Addendum No. 2
February 11, 2021

Project: Fine Arts Colton Theatre Renovation
University of South Dakota
Vermillion, South Dakota
OSE Project #0621--09X
Architecture Incorporated Project #2906

Architect: Architecture Incorporated

Revised
Box E-Control Room Audio Patch

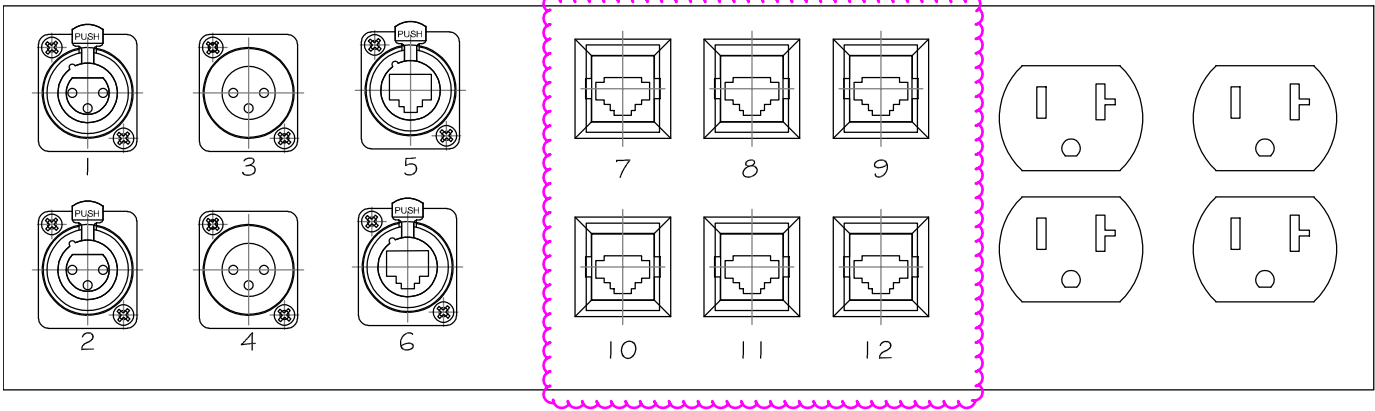
- 8) DRAWING SHEET 10.20 – RIGGING, LIGHTING, AND AV
- a) Refer to “Revised Box E-Control Room Audio Patch” drawing dated February 11, 2021 attached to the end of this addendum for routing clarifications at the Box ‘E’ faceplate.
